3589.02.02 CS7 Tooting Bec to Balham – Post Construction

In accordance with *TLRN: Recovery and Restart - TfL Engineering - Road Safety Assurance of Designs (12 May 2020)* a post-construction safety review (equivalent to Stage 3 Road Safety Audit) was requested and has been undertaken on the CS7 measures (Section 7) installed between Tooting Bec and Balham.

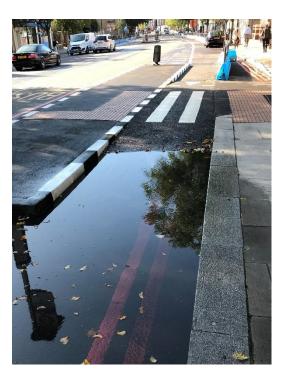
1. Northbound floating bus stop by Du Cane court (Balham High Road). There was significant ponding noted at the raised crossing to the bus stop island at the time of the site visit. Whilst the raised table has been installed with a drainage pipe, this had become blocked with leaves. Cyclists were observed to brake suddenly or swerve onto the footway to avoid the large puddle. There is also a risk of loss of control / skidding if surface water does not drain away, especially under freezing conditions.

It is recommended that measures are provided to prevent drainage channels becoming blocked by leaves, especially since there are a large number of mature trees nearby. This may also require regular maintenance during autumn leaf fall.
